## **Plan Change 69 Application – Supplementary Report on Greenspace/Reserve Provision from Mark Rykers, Manager Opens Space and Strategy, Selwyn District Council.**

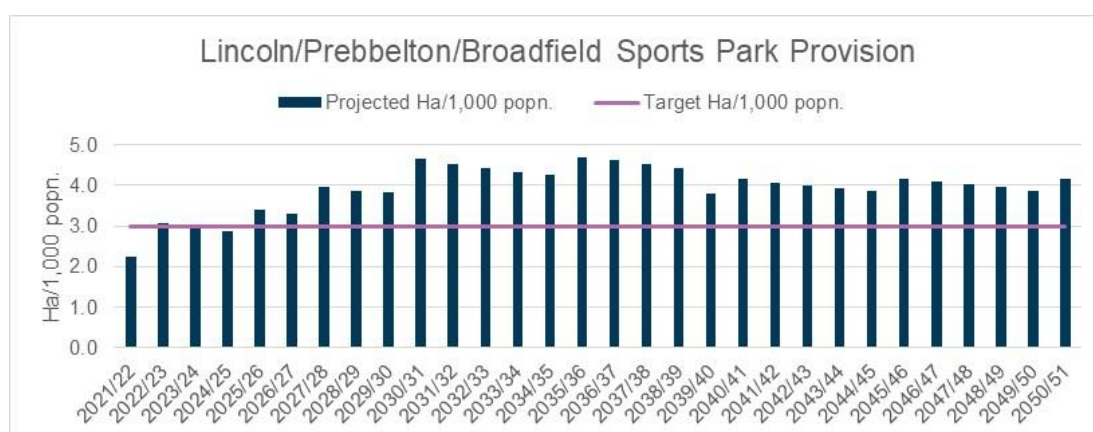
- Modelling over a 30 year period has been undertaken to determine the impact of the population generated from PC69 on sports park provision levels. This anticipates the release of 250 lots per year over an 8 year period for this development and takes account of projected population growth in the Lincoln/Prebbleton/Broadfield catchment from the Council's adopted growth model as well as planned timing for development and commissioning of additional sports park land (as provided for in the LTP and 30 Year Infrastructure Strategy).

- The modelling indicates that there is sufficient capacity within existing and planned sports parks to meet the additional population generated from PC69. This is shown in the graph below:
